APPLICATION FOR HISTORIC AREA WORK PERMIT

WE RECEIVED HAWP APPROVAL FOR AN ADDITION AND RENOVATIONS AT THE MARCH 6TH HPC. WE'RE REQUESTING MODIFICATIONS TO THOSE APPROVALS TO REDUCE THE SCOPE OF THE PROJECT AS SHOWN IN THE REVISED DRAWINGS AND REQUEST THE USE OF SUBSTITUTE MATERIALS ON THE REAR ADDITION.

7801 HAMPDEN LANE HAWP REVISION

23.0446 - FRANK-EDELBERG RESIDENCE

EXISTING SITE PLAN

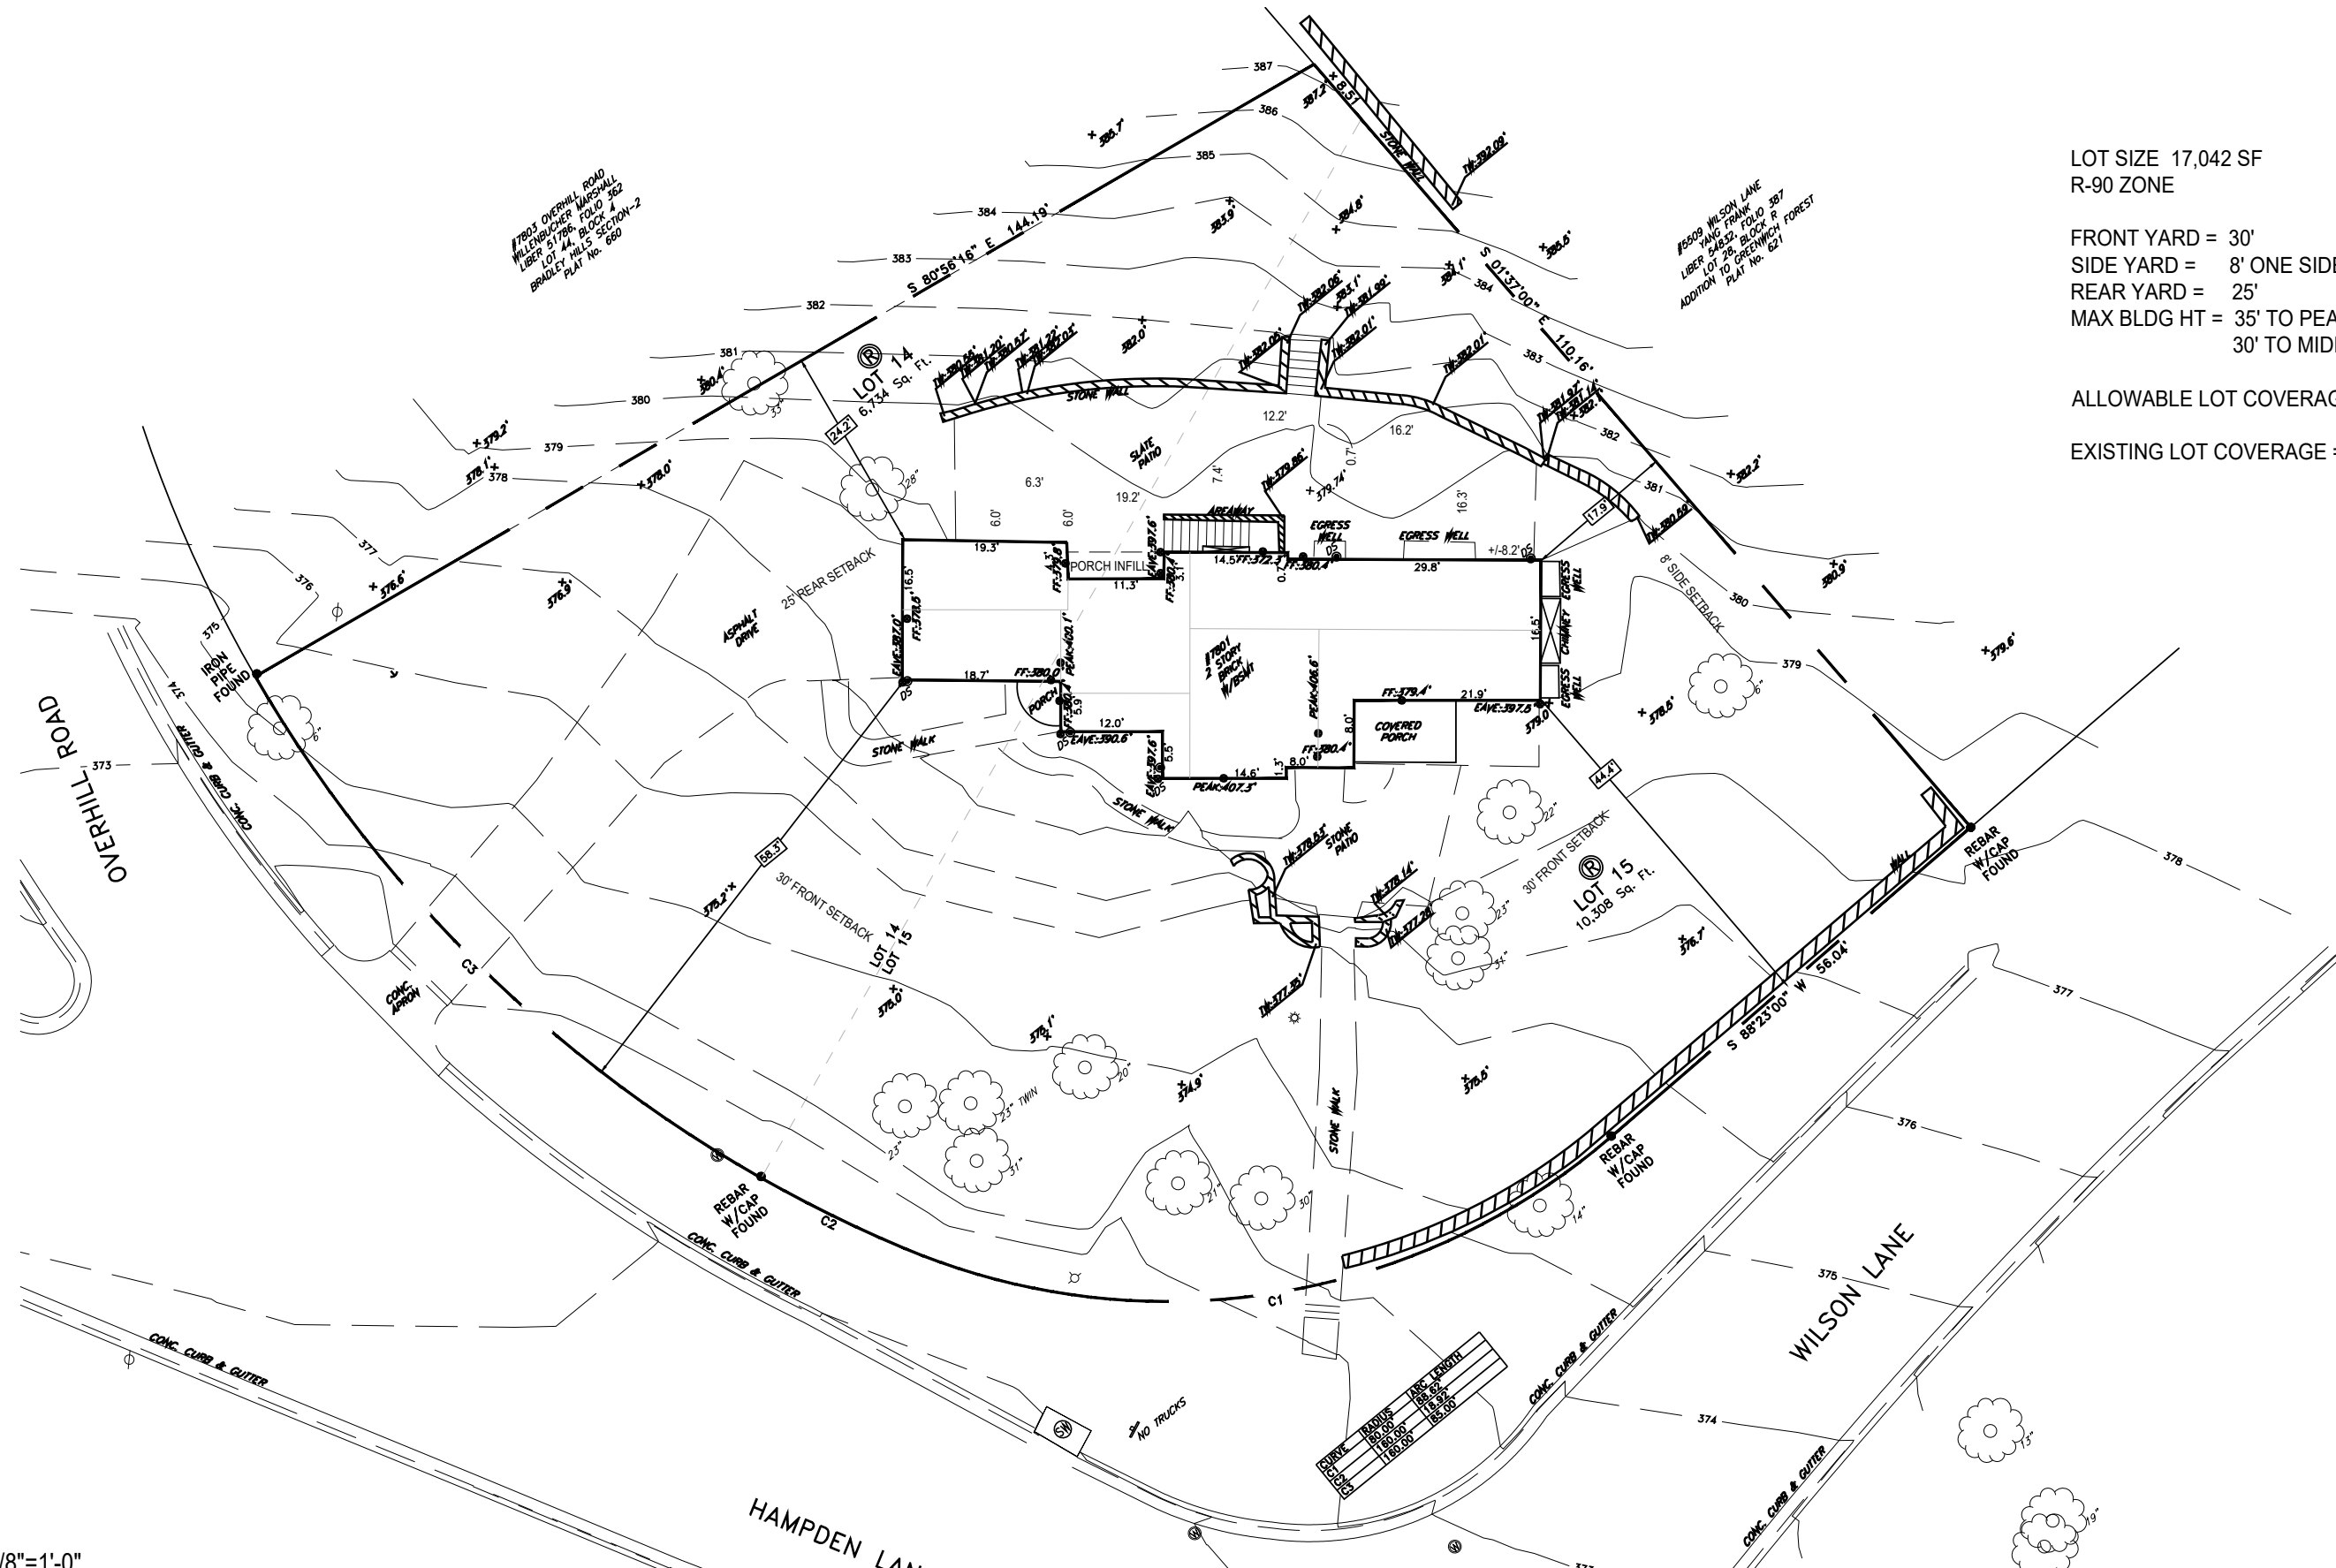
~~REDUCE SIZE OF PREVIOUSLY APPROVED REAR COVERED PORCH~~

~~2ND STORY REAR DORMER ADDITION ABOVE EXISTING 1.5 STORY ATTACHED GARAGE. REAR DORMER TO BE REMOVED FROM SCOPE~~

~~ENLARGE EXISTING REAR PATIO TO ACCOMMODATE PROPOSED ADDITION AND PROVIDE NEW MASONRY RETAINING WALL TO REPLACE EXISTING.~~

~~RETAIN AS MUCH OF EXISTING REAR RETAINING WALL AND PATIO AS POSSIBLE, TIE INTO ADDITION AND SELECTIVELY REBUILD AS REQUIRED~~

REMOVE EXISTING FRONT WINDOW WELL & WINDOW TO ACCOMMODATE NEW FRONT MASONRY AREAWAY/STEPS TO BASEMENT

PROPOSED SITE PLAN

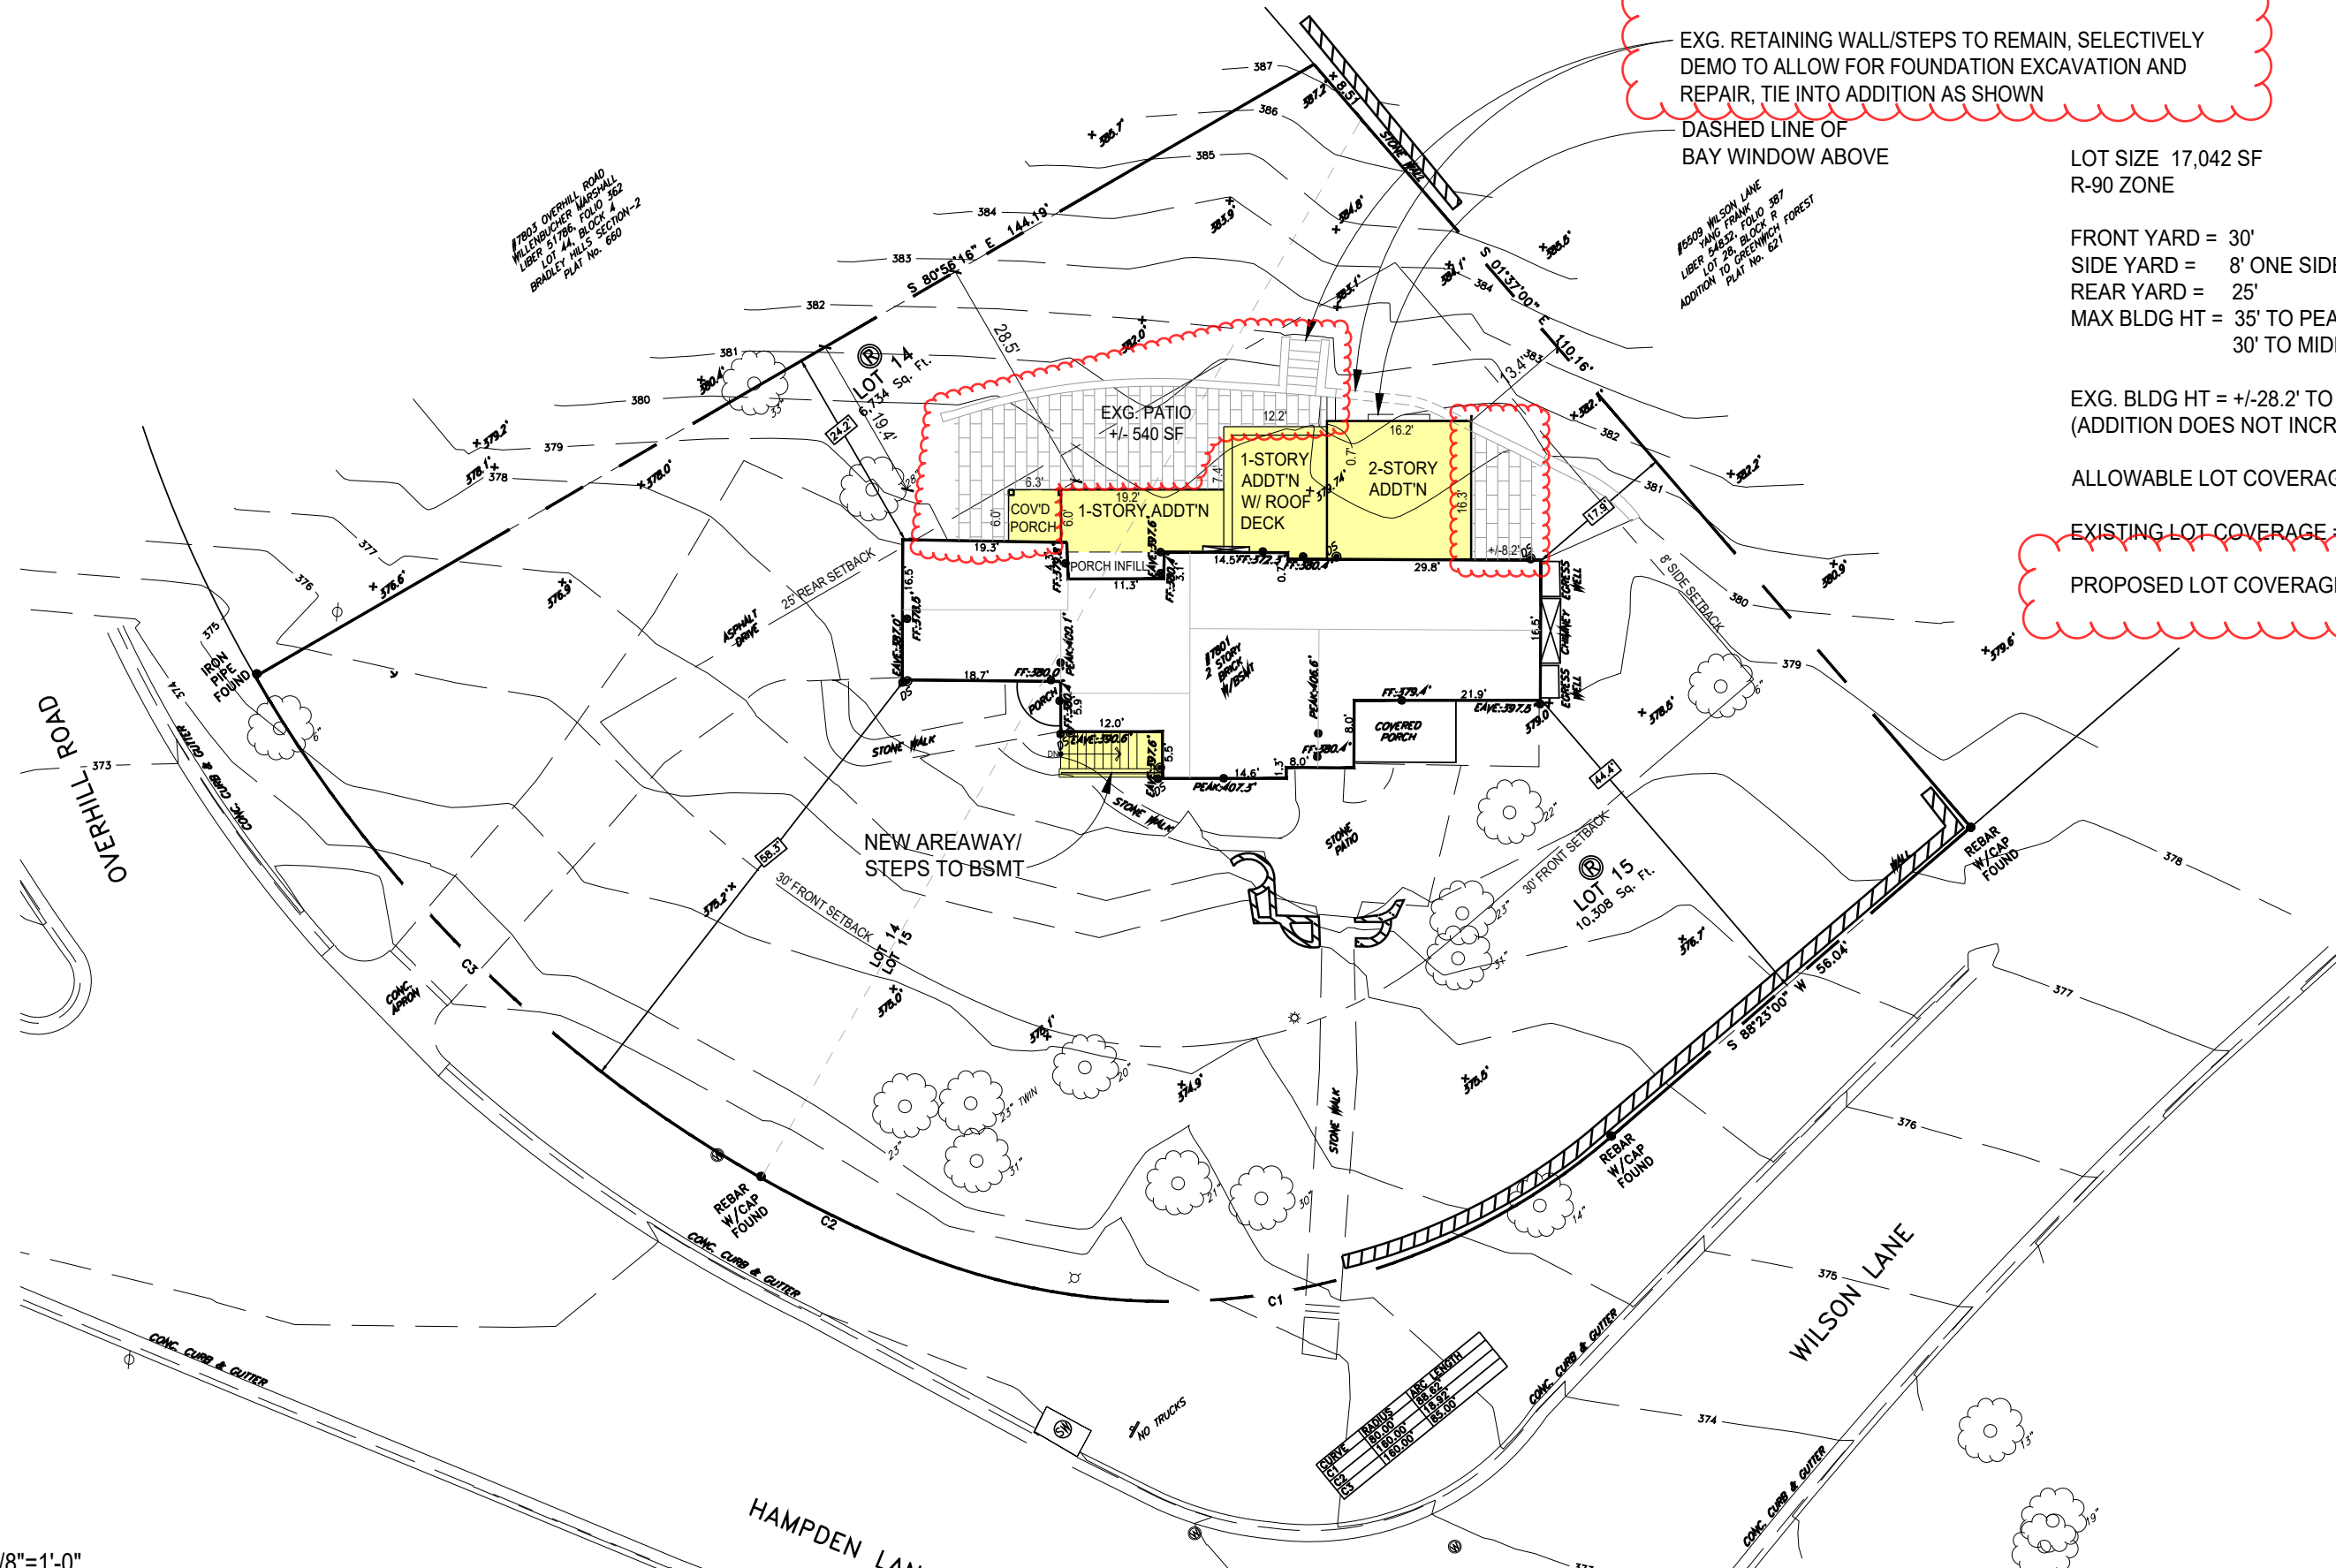
EXG. RETAINING WALL/STEPS TO REMAIN, SELECTIVELY DEMO TO ALLOW FOR FOUNDATION EXCAVATION AND REPAIR, TIE INTO ADDITION AS SHOWN

EXG. BLDG HT = +/-28.2' TO PEAK
(ADDITION DOES NOT INCREASE BLDG HT)

PROPOSED LOT COVERAGE = +/- 2,242 SF (13.2%)

MULTI-WIDTH SLATE

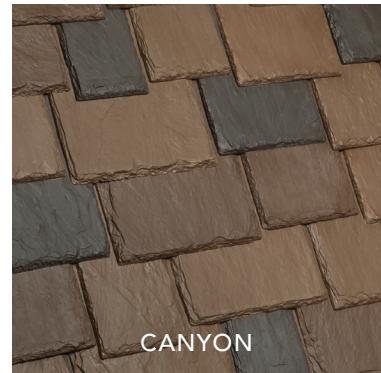
WE'RE ALSO REQUESTING TO USE SYNTHETIC SLATE ON THE REAR ADDITION ROOFS ONLY, AND SWITCH TO PTD. ALUM 6" K-STYLE GUTTERS ON THE REAR ADDITION IN LIEU OF THE HALF-ROUNDS PREVIOUSLY PROPOSED. THERE ARE CURRENTLY PTD. ALUM. K-STYLE GUTTERS ON THE REAR OF THE HOUSE AT THE GARAGE AND COVERED PORCH, WHICH WE PLAN TO RETAIN AND MATCH NOW THAT WE ARE REDUCING THE SIZE OF THE PROPOSED REAR COVERED PORCH. THE REAR OF THE HOUSE ALSO CURRENTLY HAS DRAINAGE ISSUES, AND THE HOMEOWNERS HAVE BEEN INFORMED THAT K-STYLE GUTTERS PERFORM BETTER IN HEAVY RAINS, ESPECIALLY CONSIDERING THE SLATE ROOFING AND PITCH OF THE ROOF, WHEREAS HALF-ROUND GUTTERS CAN TEND TO OVERFLOW GIVEN THEIR SMOOTH, ROUNDED PROFILE. THE PROPOSED GUTTERS ARE ON THE REAR IN AREAS THAT ARE MINIMALLY VISIBLE, SO WE DON'T BELIEVE IT WILL DETRACT FROM THE HOUSE. THE FRONT GUTTERS WILL STILL REMAIN HALF-ROUND COPPER GUTTERS AND WILL BE UPSIZED FOR BETTER PERFORMANCE PER OUR PREVIOUS APPROVALS.
